Subject: **Palo Verde Nuclear Generating Station (PVNGS)
Units 1, 2, and 3
Docket Nos. STN 50-528, 50-529, and 50-530
License Amendment Request to Revise Technical Specifications to
Incorporate Updated Criticality Safety Analysis**

Description and Assessment of Proposed License Amendment

The following specific TS changes are proposed as part of the updated criticality safety analysis. Marked-up TS pages are provided in Attachment 1 and revised (clean) TS pages are provided in Attachment 2.

Tables 3.7.17-1 through 3.7.17-5, Figure 3.7.17-1,

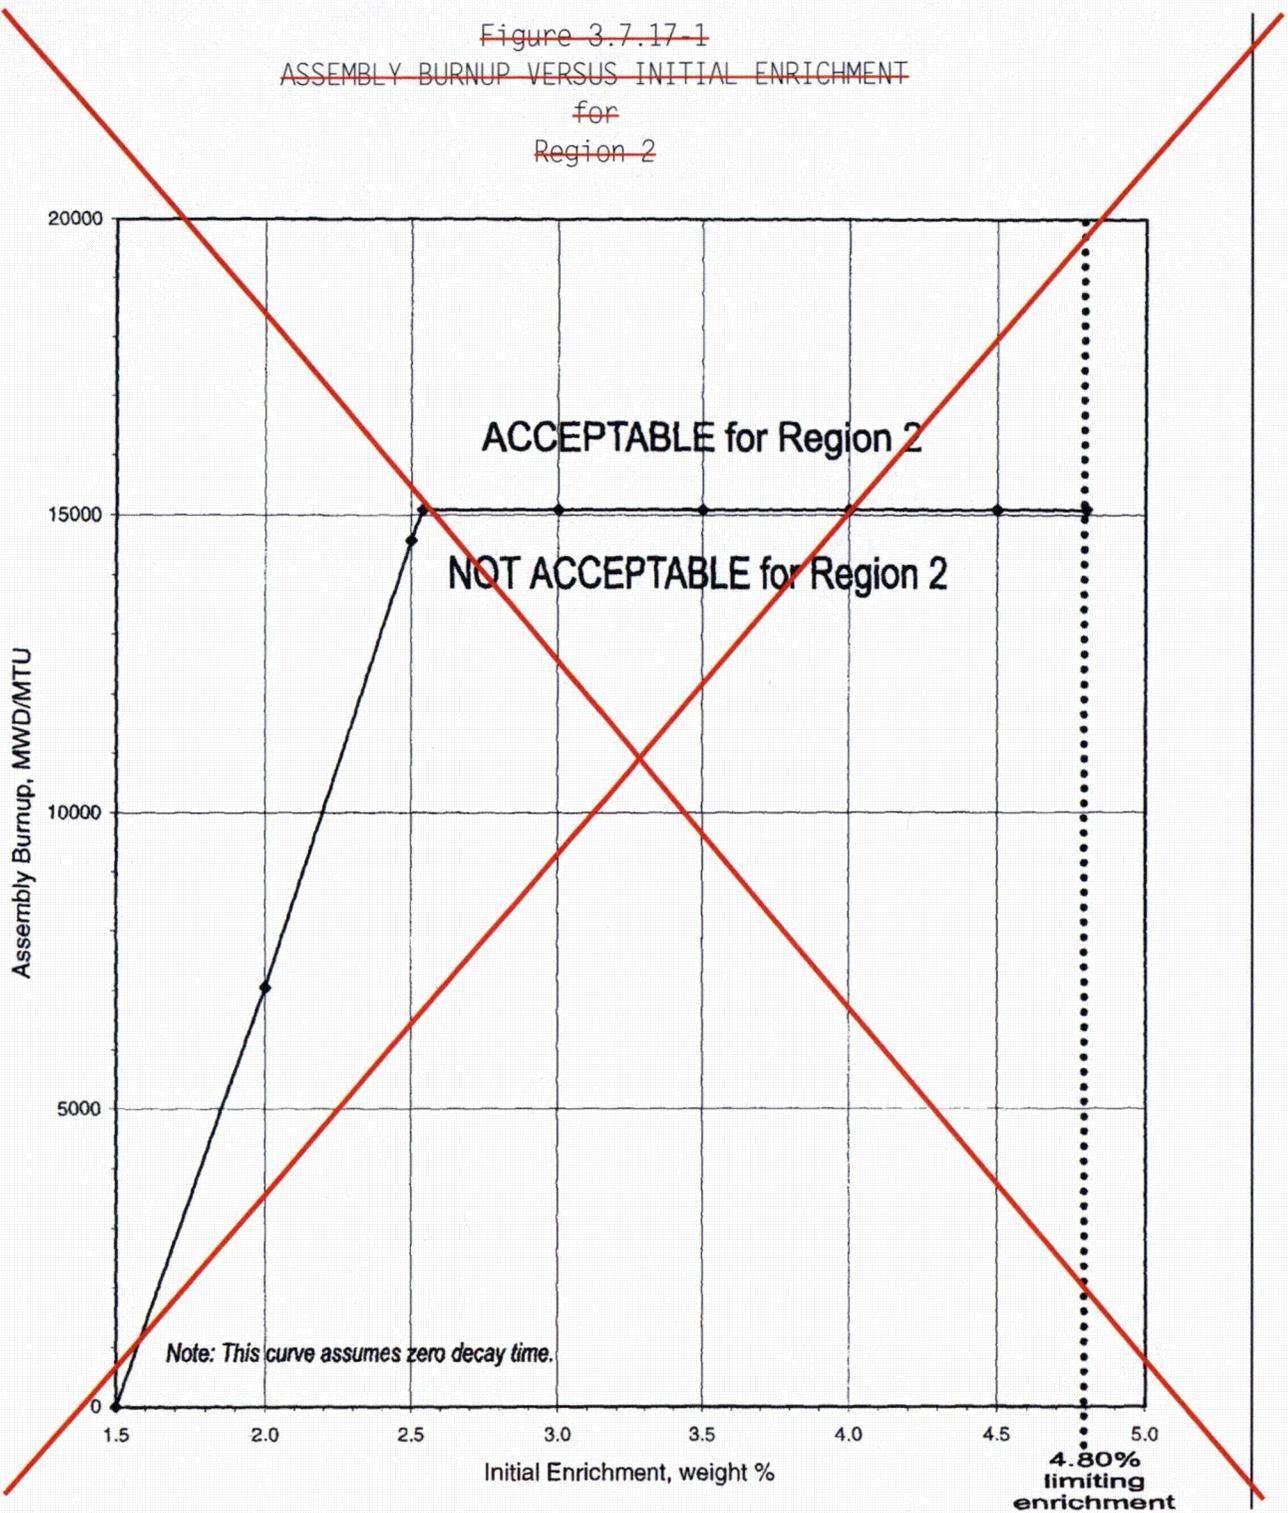
Insert new Tables 3.7.17-1 through 3.7.17-5 and
Figure 3.7.17-1 (total 6 pages) here.

~~Figure 3.7.17-1~~
~~ASSEMBLY BURNUP VERSUS INITIAL ENRICHMENT~~
~~for~~
~~Region 2~~

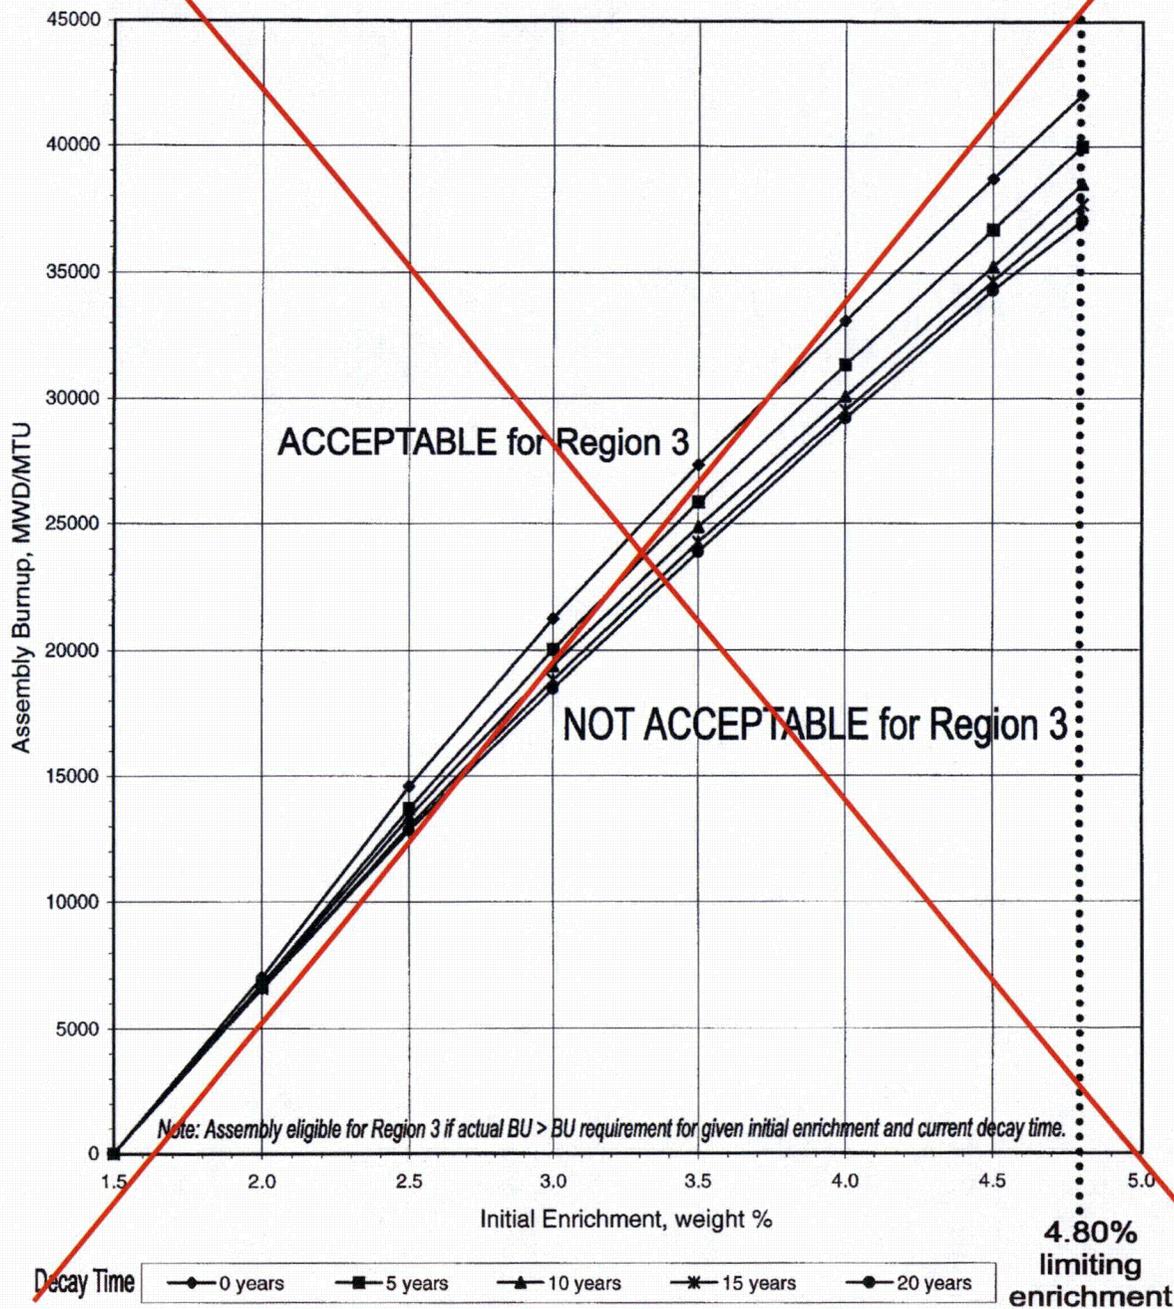
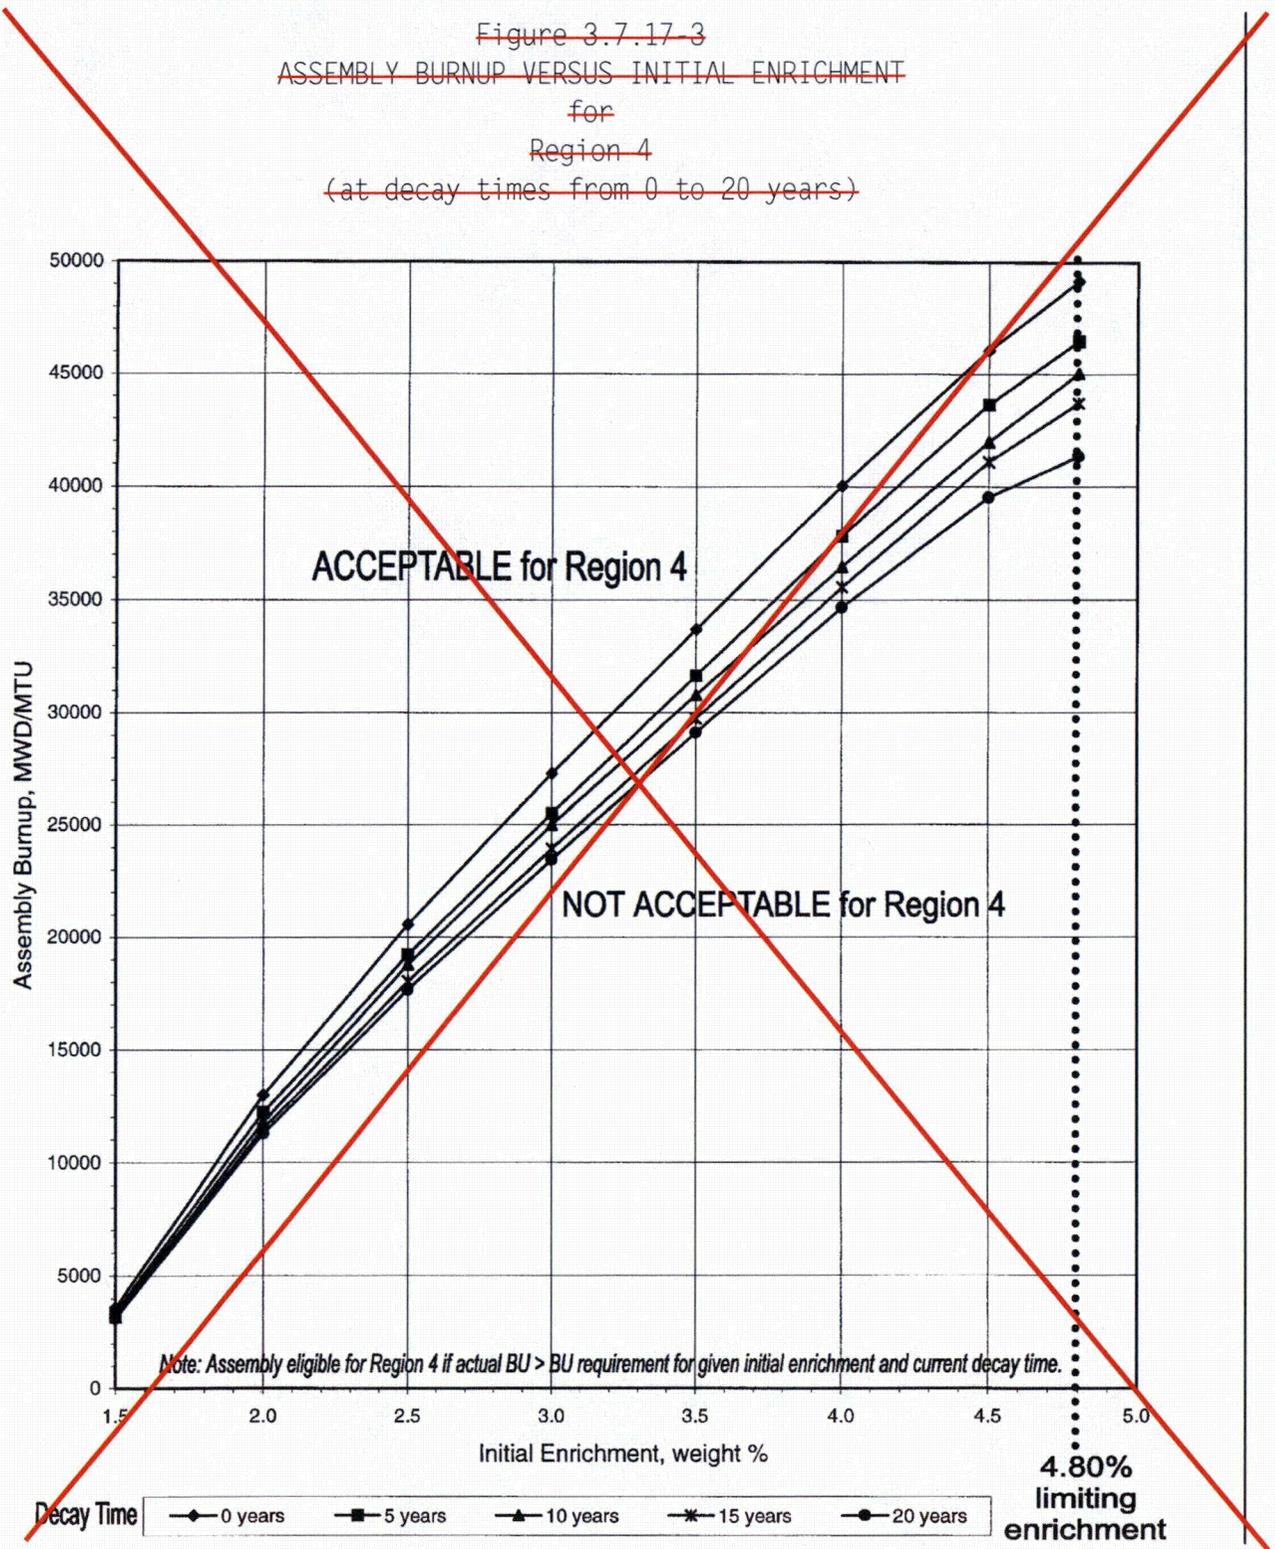
- TS 3.7.17, *Spent Fuel Assembly Storage*
 - Revise the LCO statement and surveillance requirement statement to reflect the updated spent fuel assembly storage requirements resulting from WCAP-18030-P
 - Add Tables 3.7.17-1 through 3.7.17-5 to define the Fuel Regions
 - Replace Figure 3.7.17-1 to define the Allowable Storage Arrays
 - Delete Figures 3.7.17-2 and 3.7.17-3 (information is replaced by Tables 3.7.17-1 through 3.7.17-5)
